Access Compliance Report

Public Rights-of-Way (Curb Ramps)

Intersection ID: 23171	Main Street: CAMILLA_DR	Cross Street: MORROWICK_RD	Location: SW
ADA ID: 36B59EC160A1	Ramp Type: PerpDiag	Initial Pass/Fail: Fail	Overall Compliance: No
		Severity Score: 25

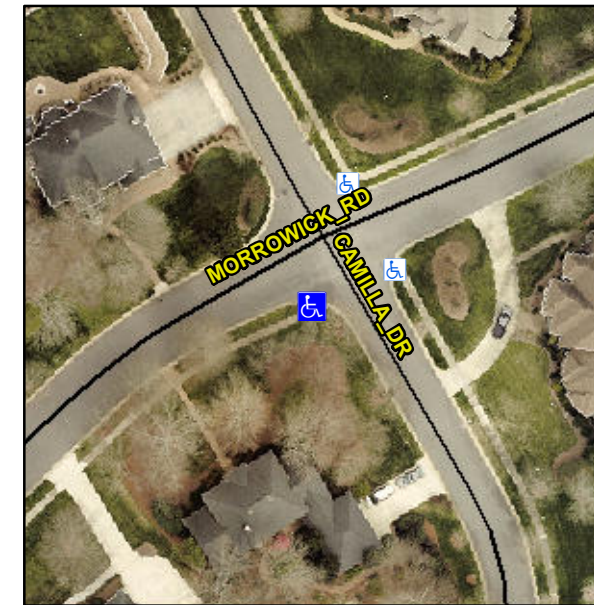
Not Found, R304.5.3

Compliance	Description	Data	Compliance	Description	Data
N/A	Ramp Length (in)	48.0	Yes	Ramp Slope (%)	5.8
Yes	Ramp Width (in)	48.0	No	Ramp XSlope (%)	8.1
N/A	Flare Type LT	N/A	N/A	Flare Type RT	N/A
N/A	Flare Slope LT (%)	N/A	N/A	Flare Slope RT (%)	N/A
N/A	Flare Traversable LT?	N/A	N/A	Flare Traversable RT?	N/A
N/A	Landing Length (in)	N/A	N/A	DWS Provided?	N/A
N/A	Landing Width (in)	N/A	N/A	DWS Contrast?	N/A
N/A	Landing Slope (%)	N/A	N/A	DWS Length (in)	N/A
N/A	Landing X Slope (%)	N/A	N/A	DWS Full Width?	N/A
N/A	Landing Curb? (Y/N)	N/A	N/A	DWS Offset (in)	N/A
N/A	Shared Landing?	N/A			
N/A	Gutter Ponding?	N/A	N/A	Gutter Slope (%)	N/A
N/A	Gutter Lip Ht (in)	N/A	N/A	Gutter X Slope (%)	N/A
N/A	Painted X Walk1?	No	N/A	Painted X Walk2?	No
	X Walk 1 Direction	To E		X Walk 2 Direction	To N
N/A	X Walk 1 Width (in)	N/A	N/A	X Walk 2 Width (in)	N/A
	X Walk 1 Slope (%)	9.0		X Walk 2 Slope (%)	3.8
	X Walk 1 X Slope (%)	4.6		X Walk 2 X Slope (%)	5.5

Remove & Replace Curb Ramp With Two New Directional Ramps or Equivalent.
